Re: Palomas Peak Ph. 2 Office Development/ 8300 Palomas Ave. NE
Request for Certificate of Occupancy
Transportation Development Final Inspection
Engineer's Stamp dated 2-12-21(D19-D031)
Certification dated 3-30-22

April 7, 2022
Project: Palomas Peak, 8300 Palomas Ave NE
Subject: TCL Certification for D19D031
30-Day Temporary Certificate of Occupancy

Palomas Peak Ph. 2 Office Development
8300 Palomas Ave. NE
Albuquerque, NM 87109

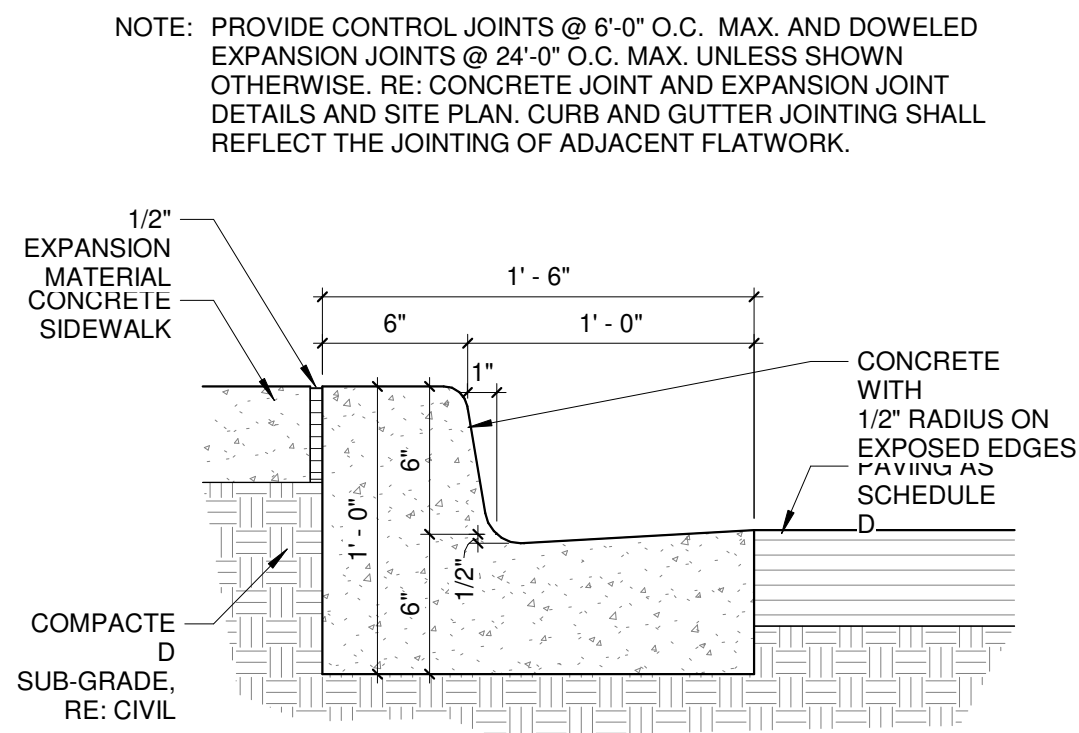
- Paint the curb that located at the northeast side of the driveway entrance with yellow. Just the segment that parallel with the ADA ramp, for tripping hazard issue.

- Please see images below of curb segment painted bright yellow.

A1 SITE PLAN
1" = 20'-0"

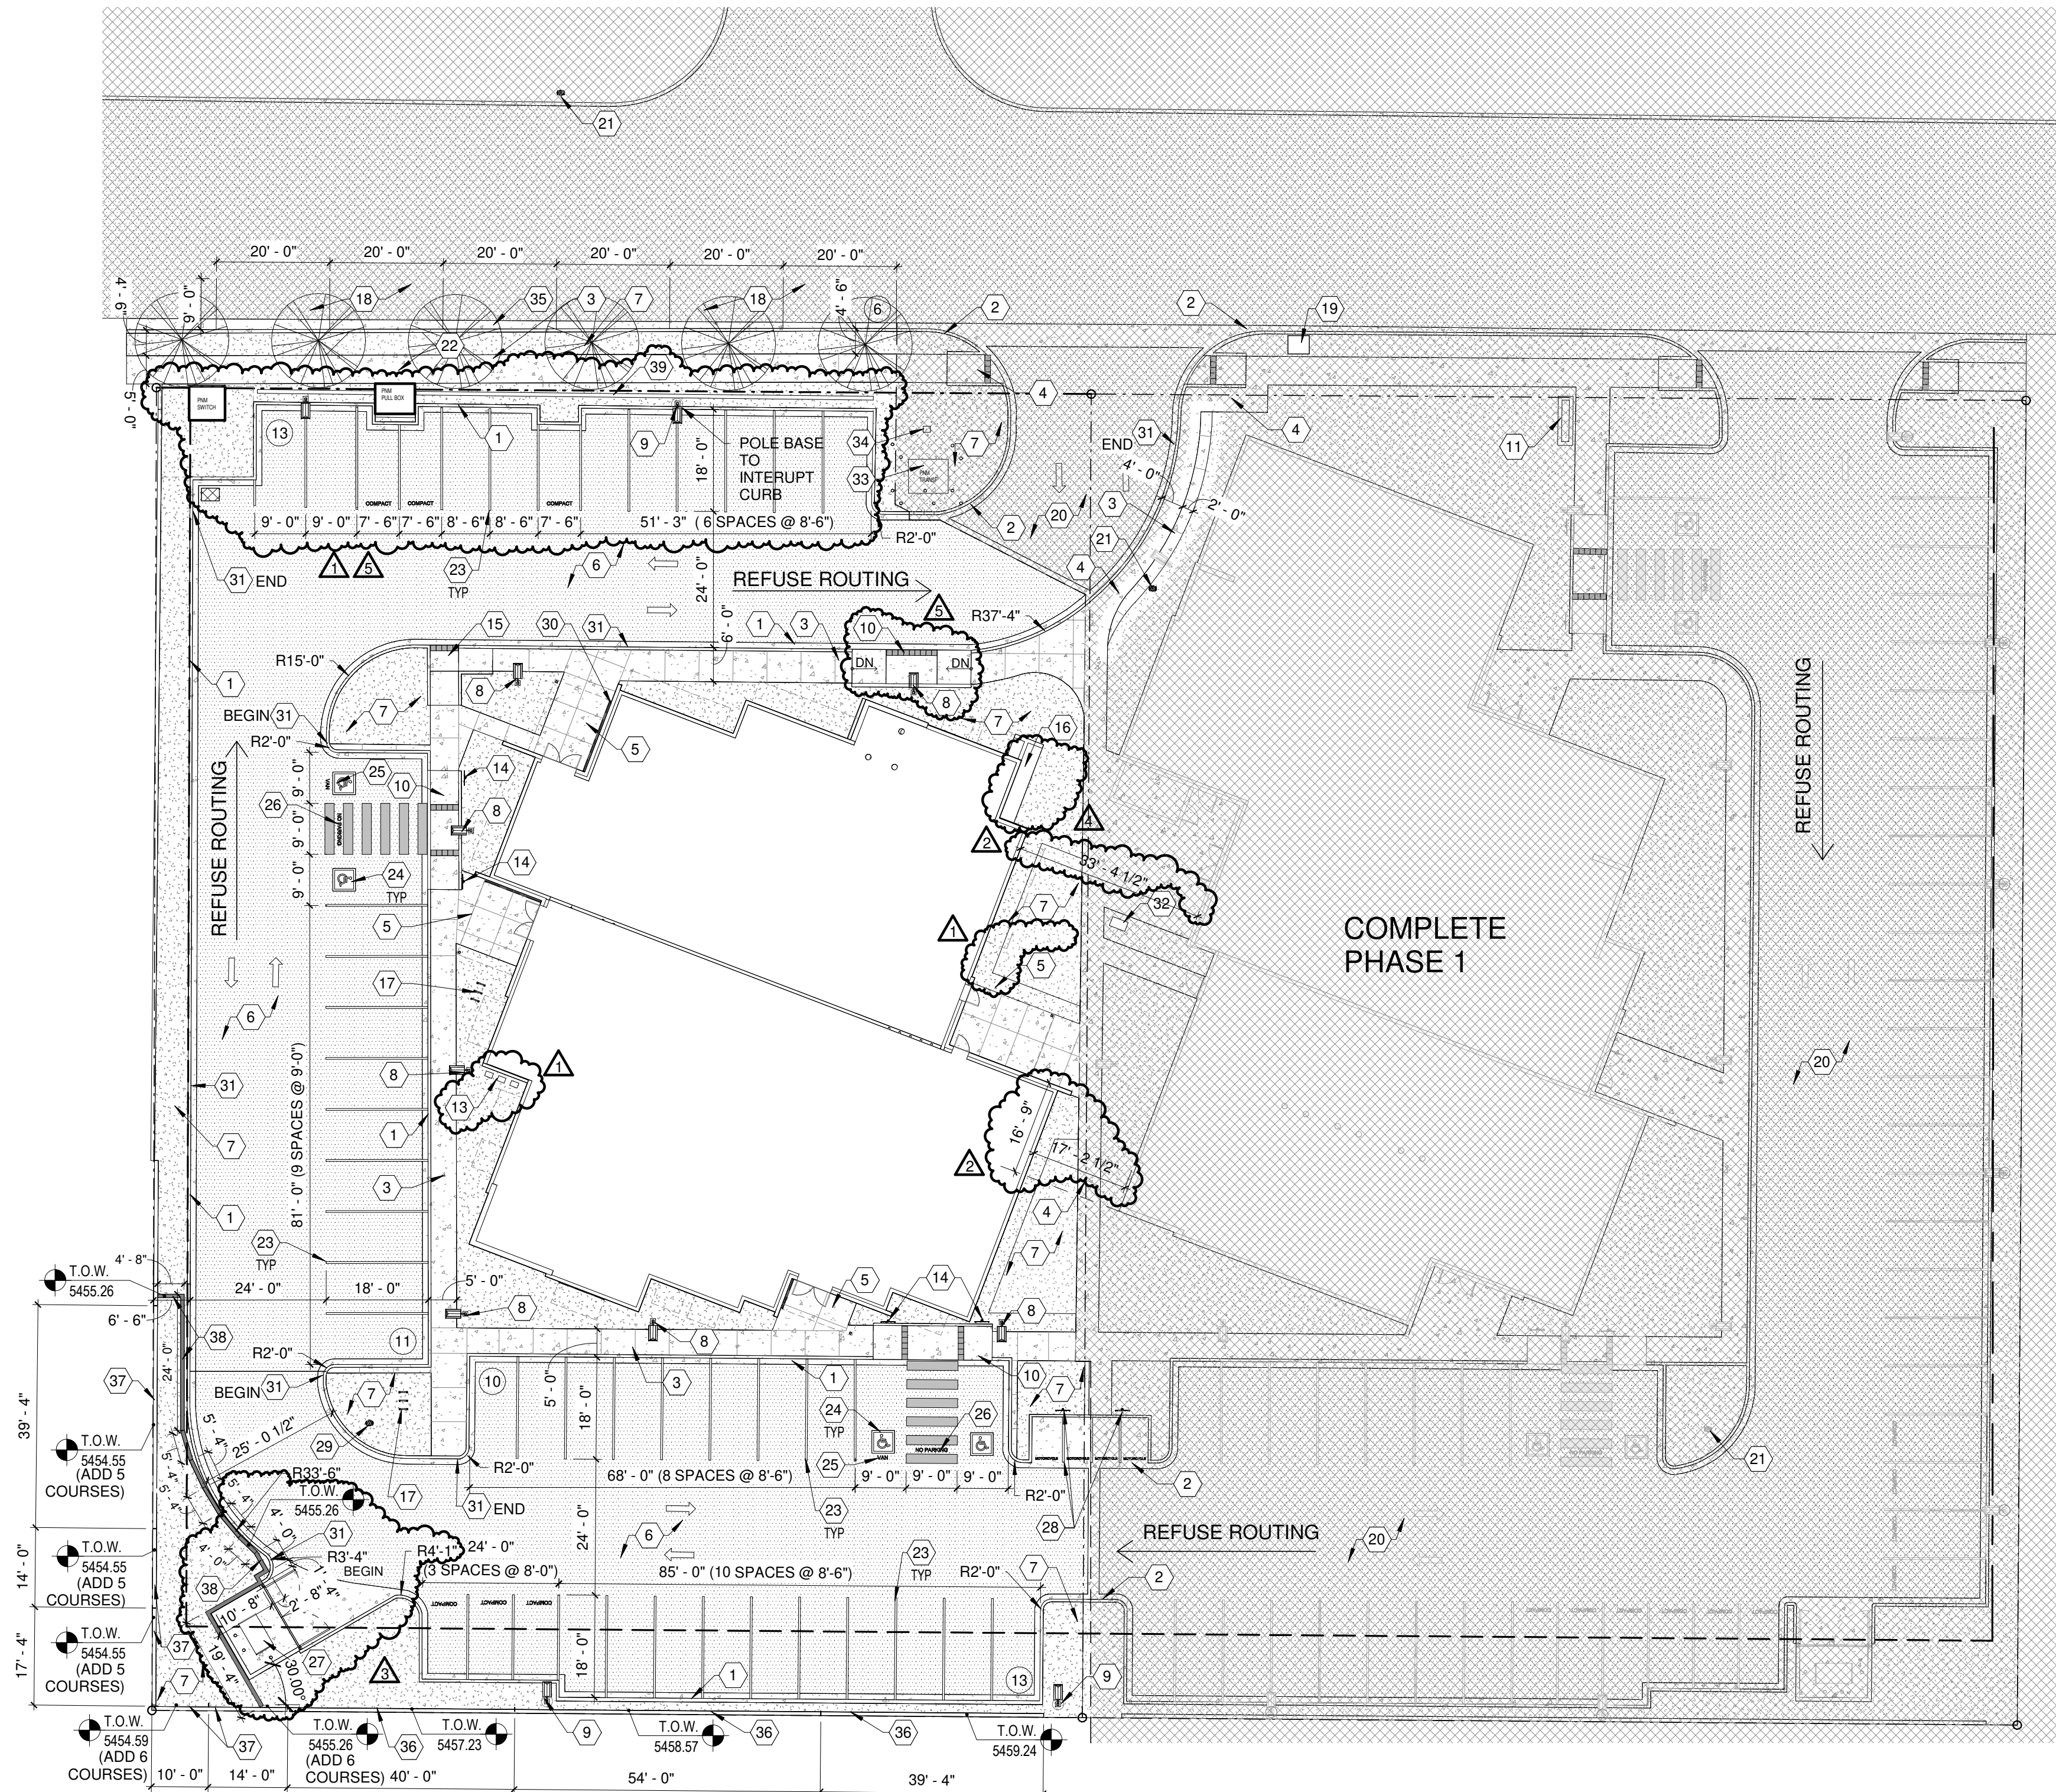
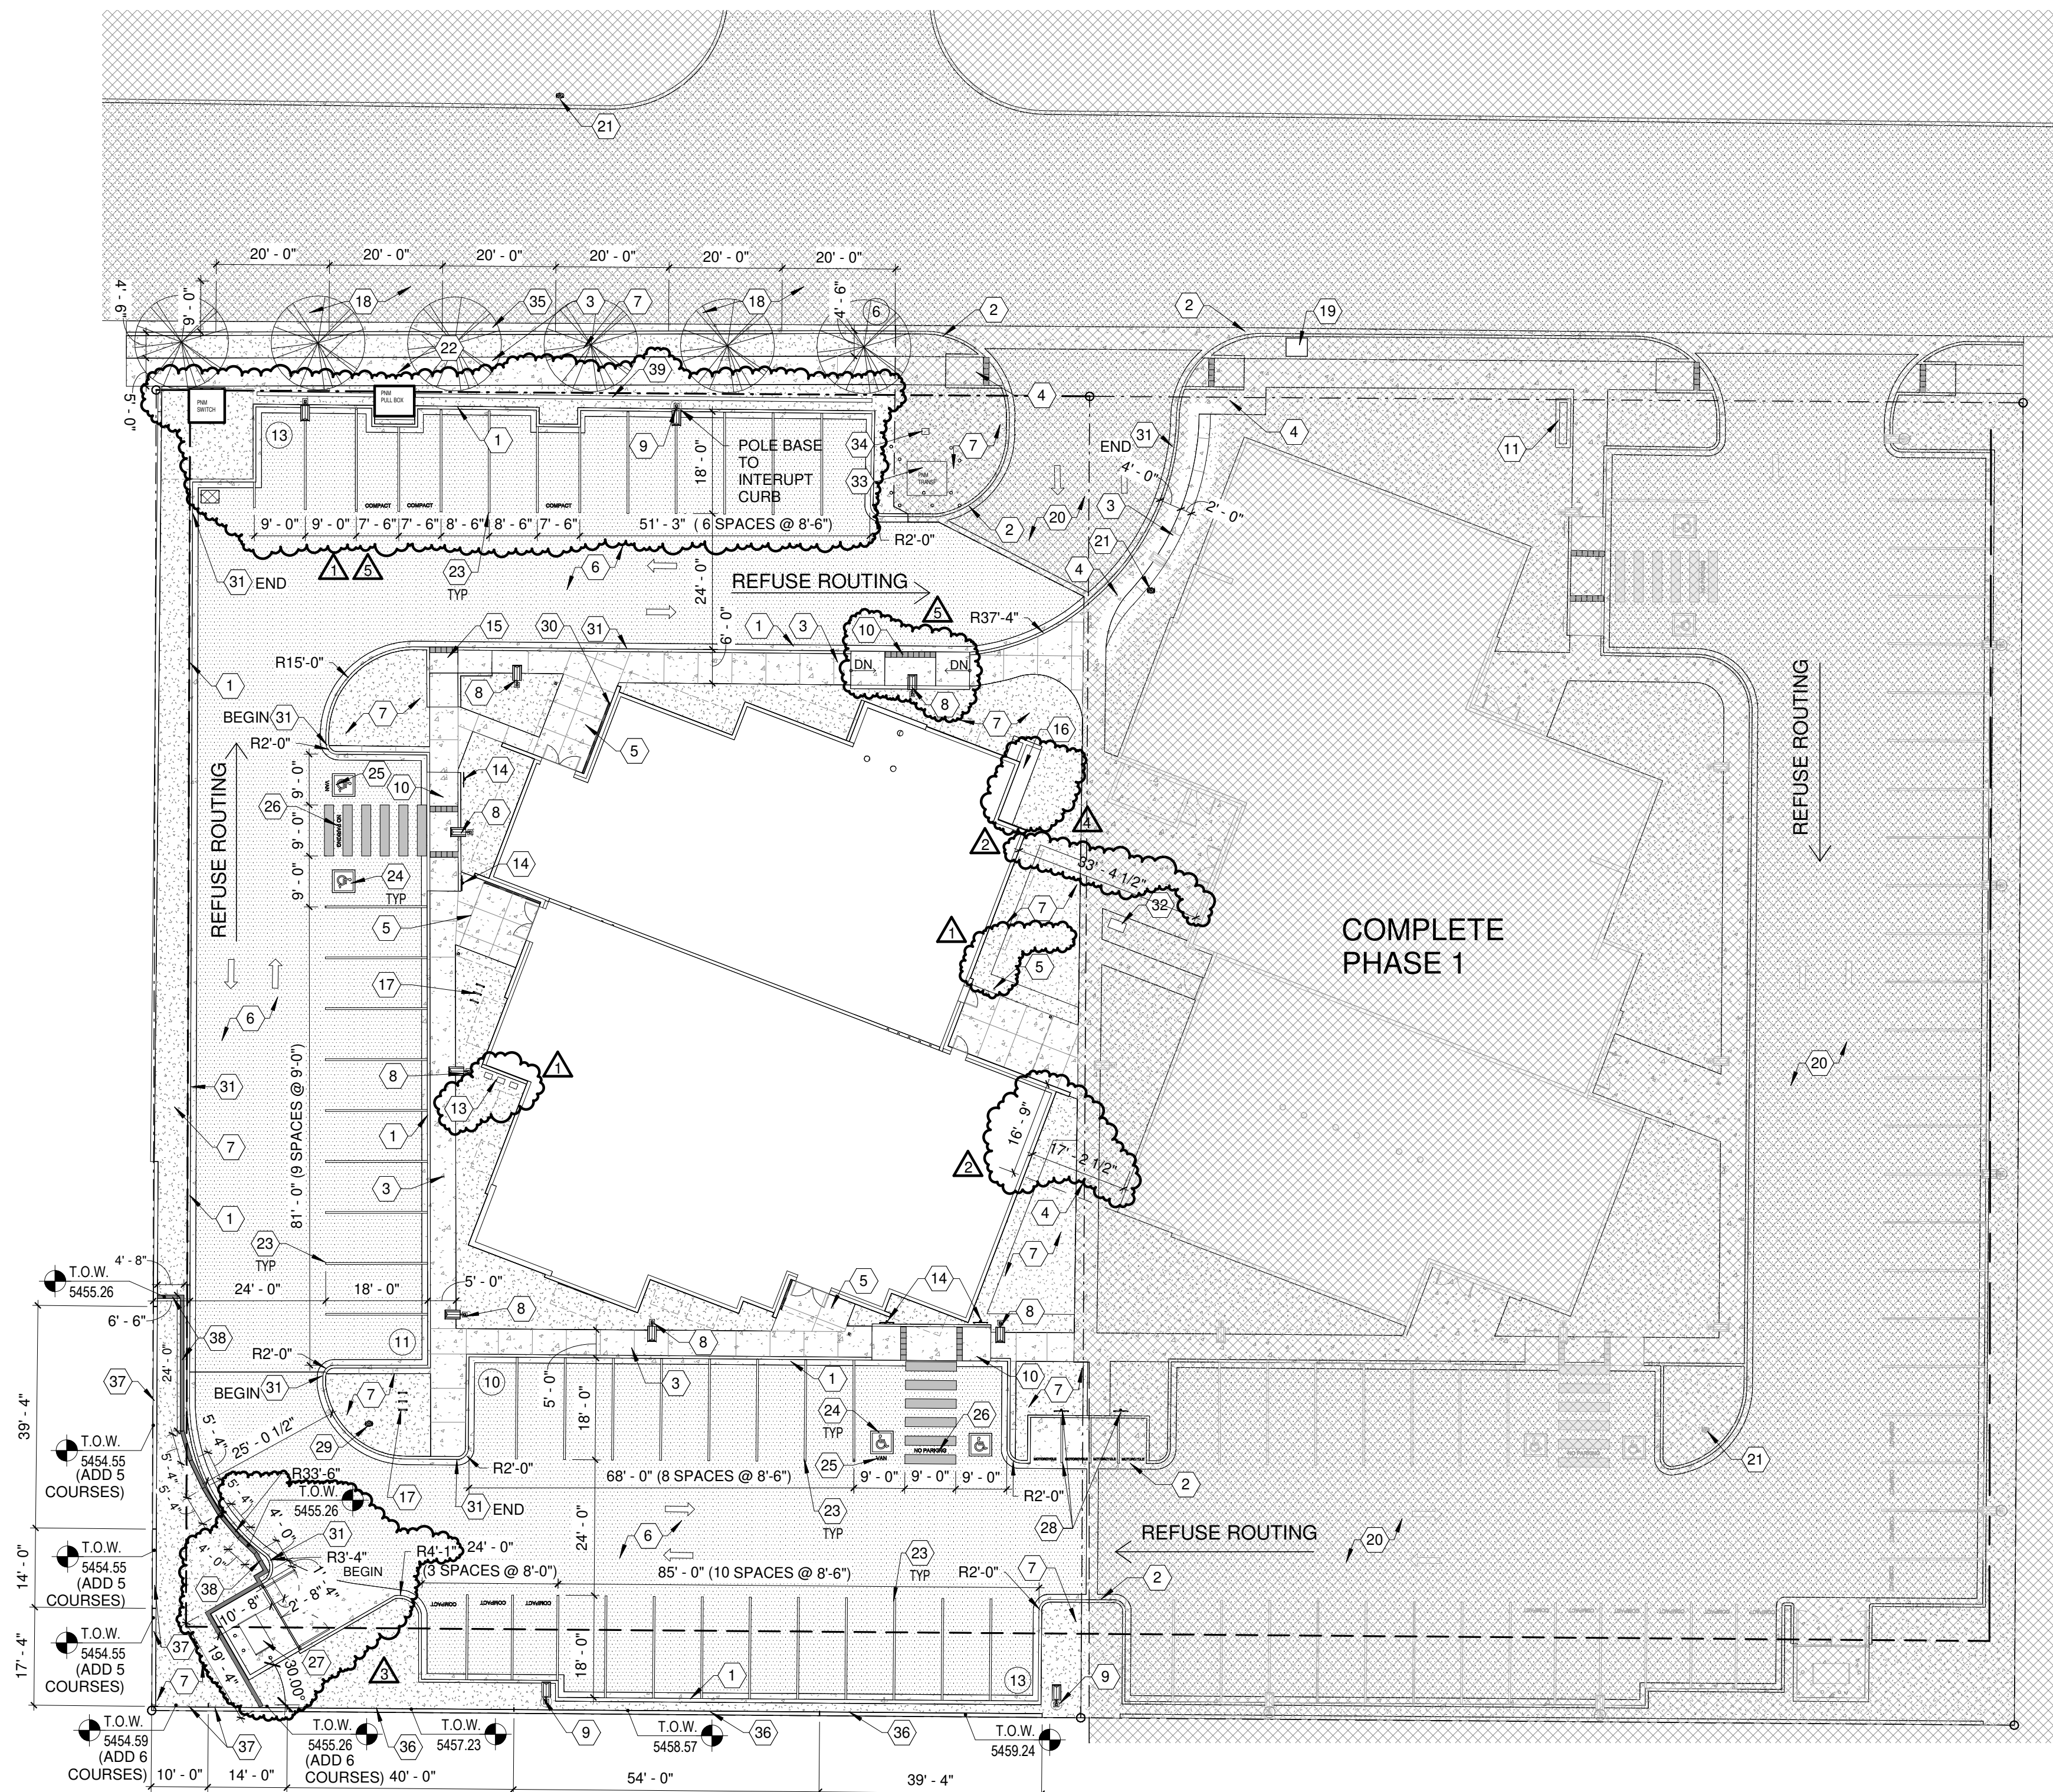
- There is a new ramp on the north side of the building, please red mark the approved TCL (add a key note for this ramp).

- Please see attached revised site plan with ramp indicated and clouded on the north side of the building.
